ETC® Release Note

Eos®/ Ion™ Lighting Control Family Software

Version 1.4.0 software

500003895

Key-Cap Update

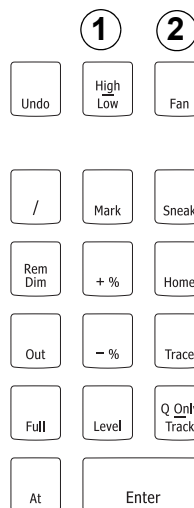
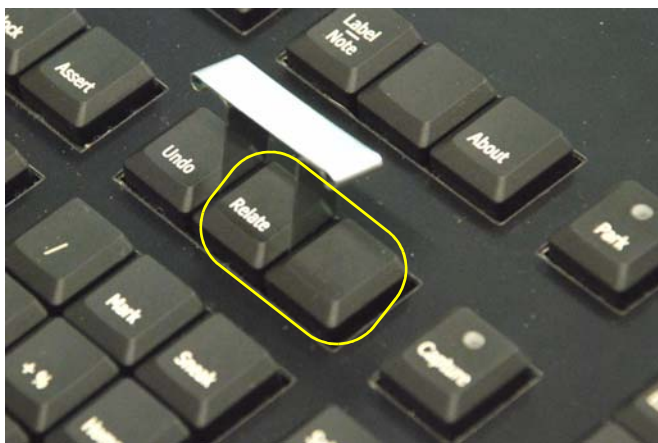
From Eos v1.3.1 to v1.4.0, two keys have been re-mapped and require that you change the physical keys on the console keyboard to match the software.

- Step 1: Use the key puller provided to remove the two keys shown below in the order indicated below.
- Step 2: Place the keys in their new correct locations and press them down firmly.
- “High/Low” replaces “Relate” and “Fan” replaces the blank key.

Below is the correct orientation to use the key puller for these keys.
Remove “Relate” and the adjacent blank key.

Remove the keys in the order shown by the numbers next to each location.

This is the correct final position for the keys.
“High/Low” replaces “Relate”.
“Fan” replaces blank.
